**RE: TR A-1 Plat of TRS A-1 & A-2 Sunport Municipal Addn. (M16D024C)
2200 Sunport Blvd. SE
Grading and Drainage Plan
Engineers Stamp Date 8/26/2022**

Based upon the information provided in your submittal received 8/26/2022, the following comments must be addressed prior to approval:

Project Title: SUNPORT CELL PHONE LOT **Building Permit #:** BP-2022-22331 **Hydrology File #:** N/A

PROPOSED DRAINAGE PLAN
Scale: 1" = 40'

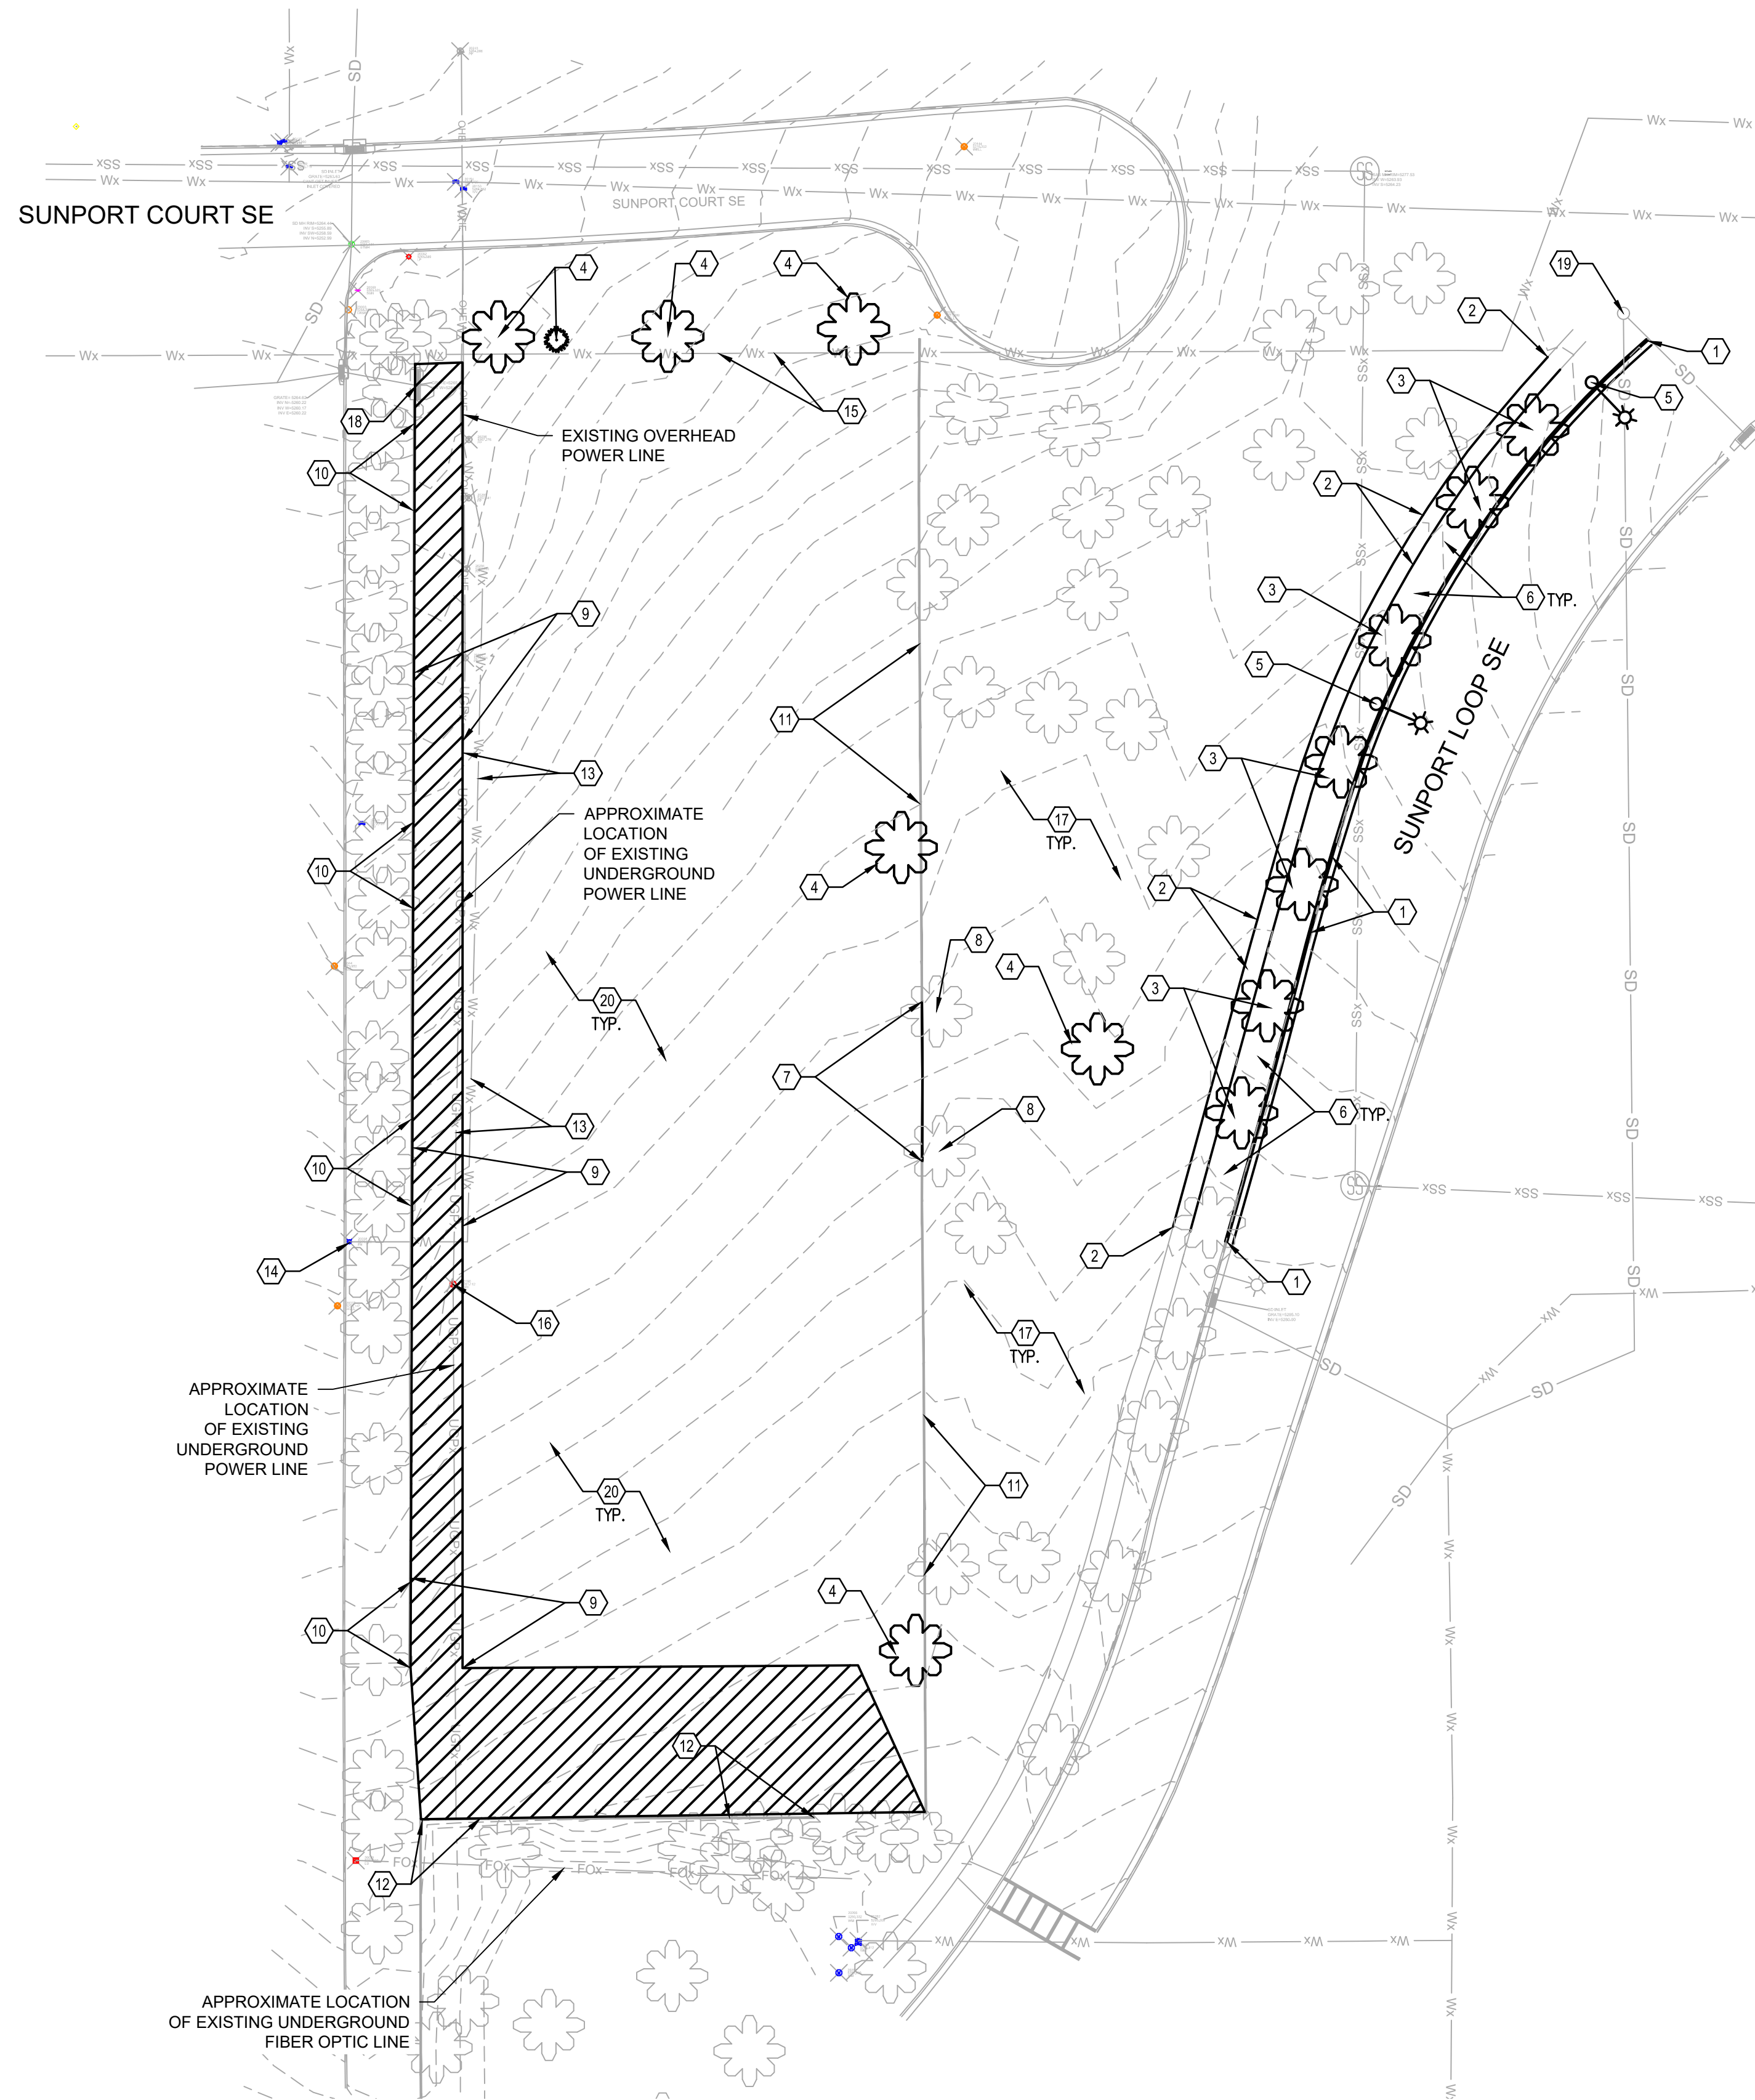
- 4) Please double check the treatment used in your runoff calculations both under the existing and proposed conditions. Under existing conditions, the treatment C is at 70%. It appears that the site is about 50% B. under the proposed conditions percentage D might be higher than show.

- 6) First Flush Volume (using storm water quality pond/retention pond) must be provided per the DPM. Detention ponds as mentioned on the plan does not address the First Flush Volume requirements.

DEMOLITION PLAN - AIS CELL PHONE LOT

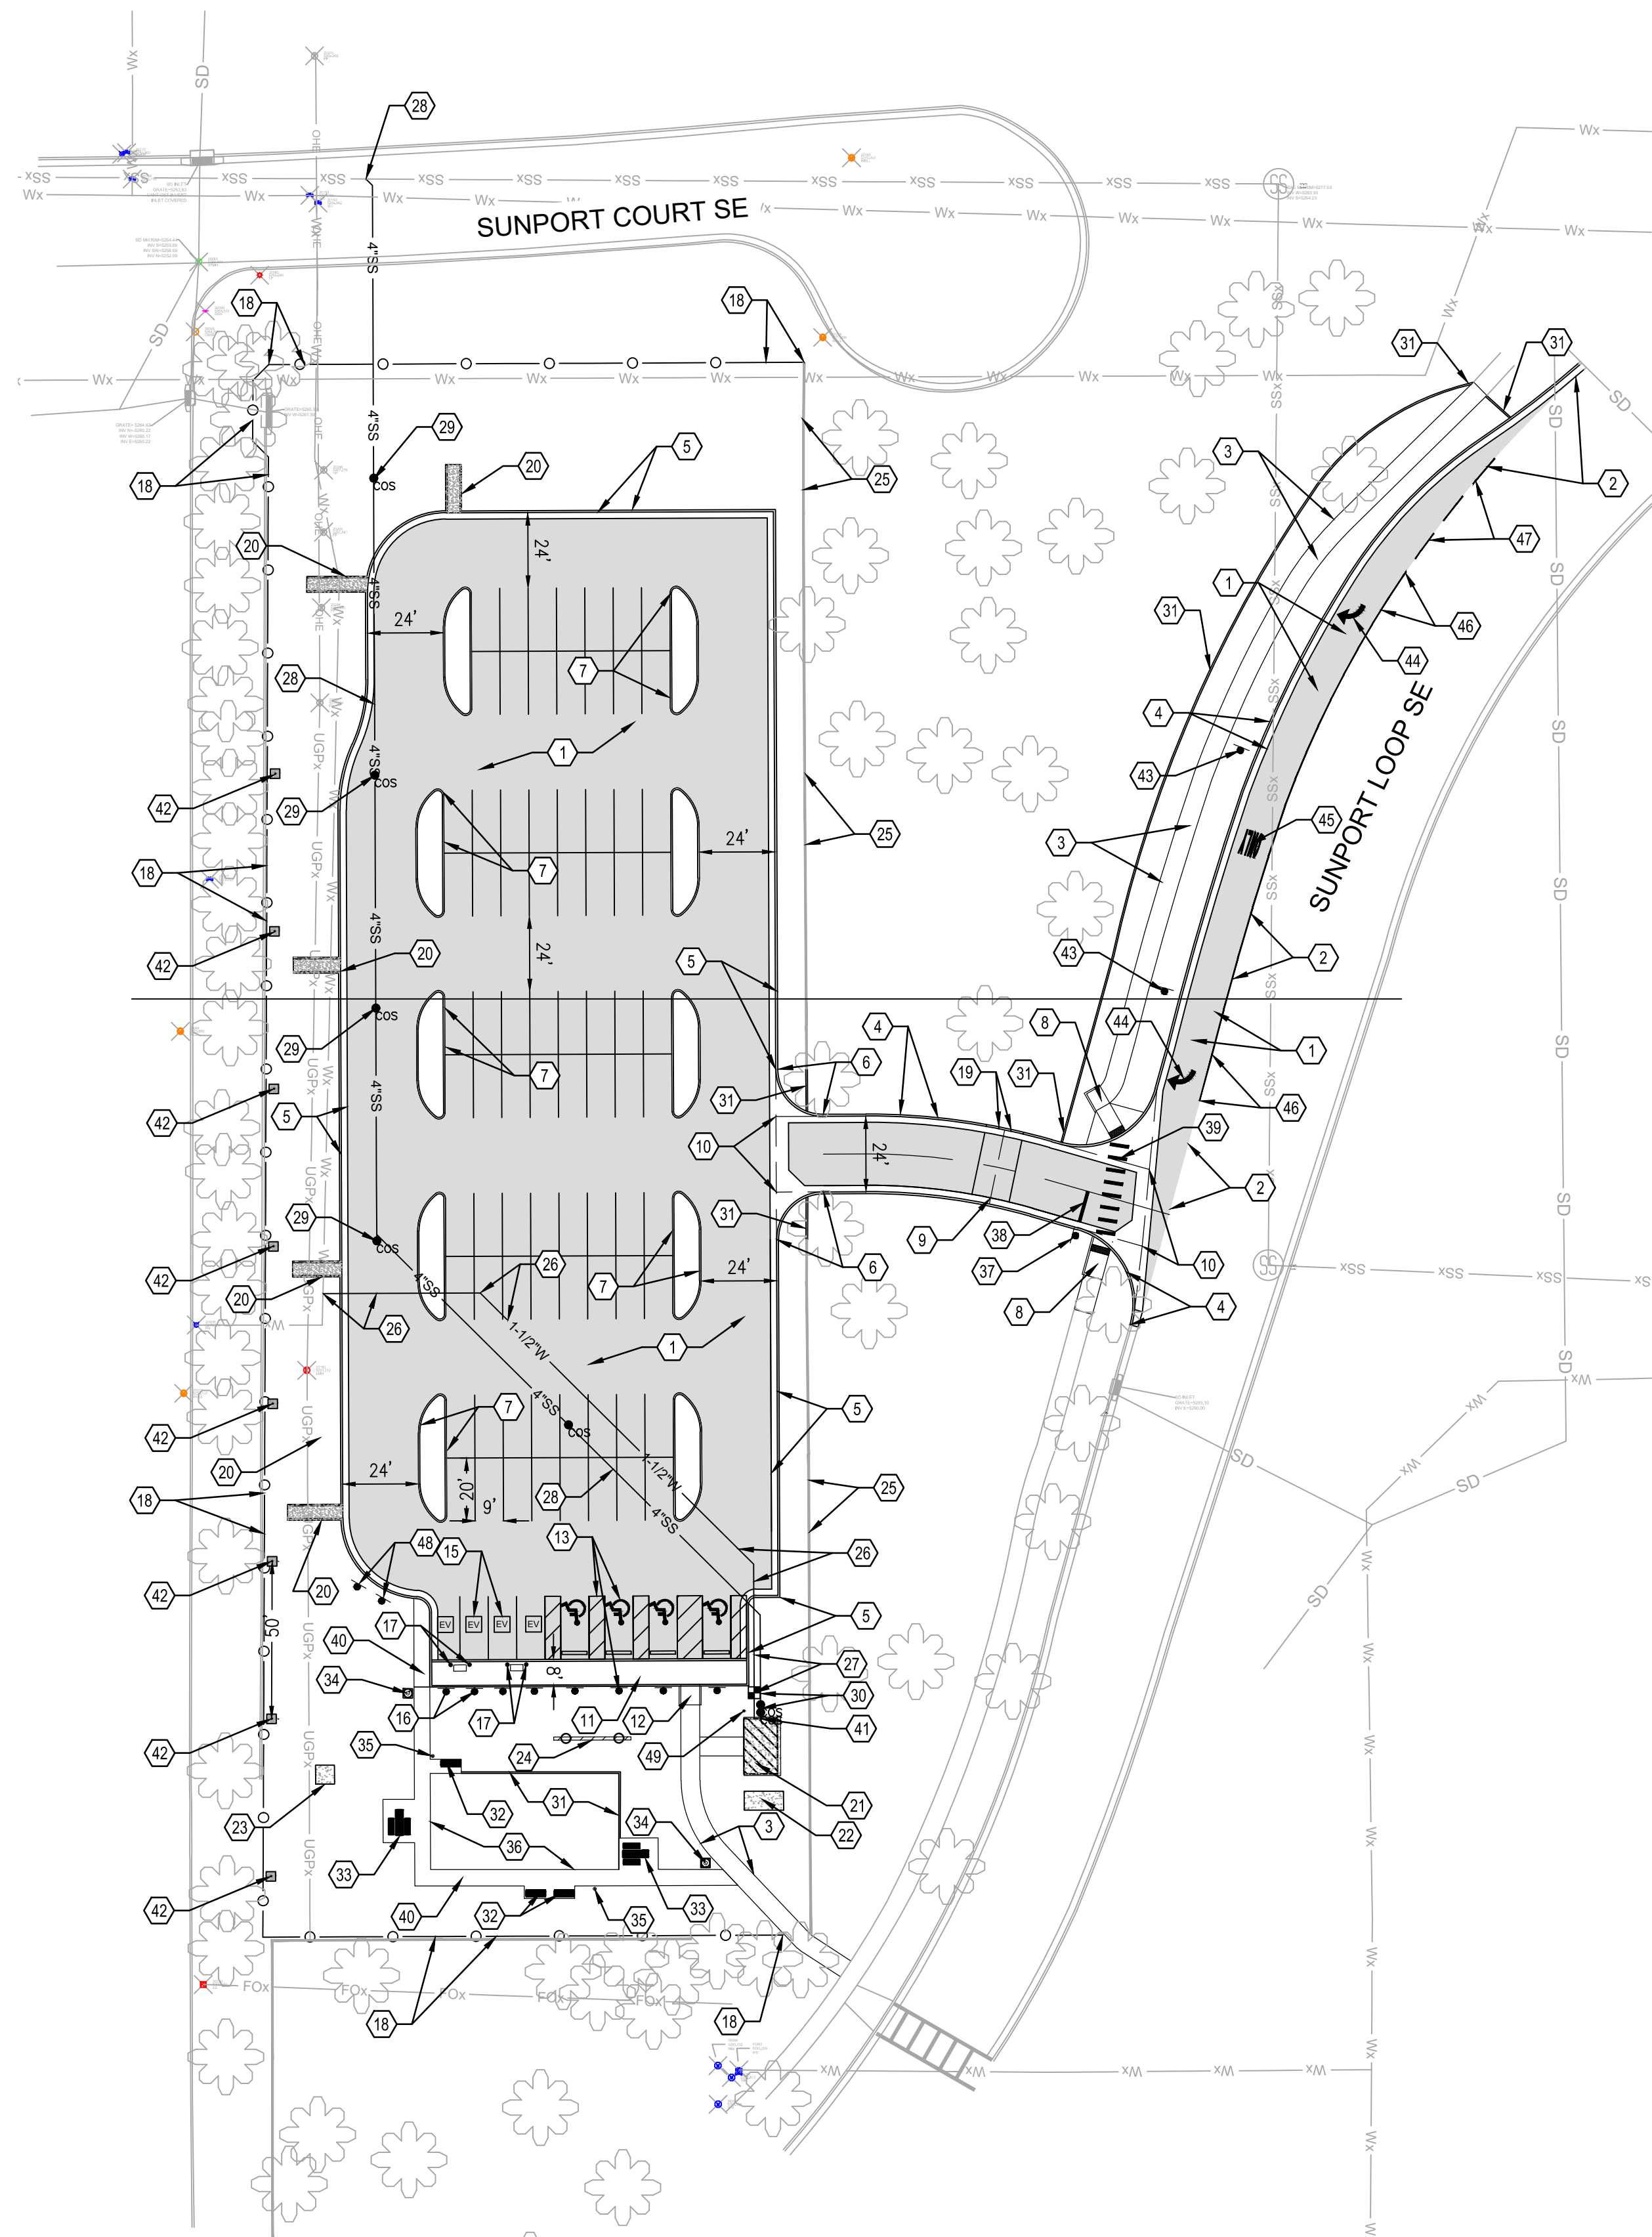
- 1) How many mature trees will be taken out as part of the deceleration lane and entrance construction. It does not appear that all existing three are shown on the plan.
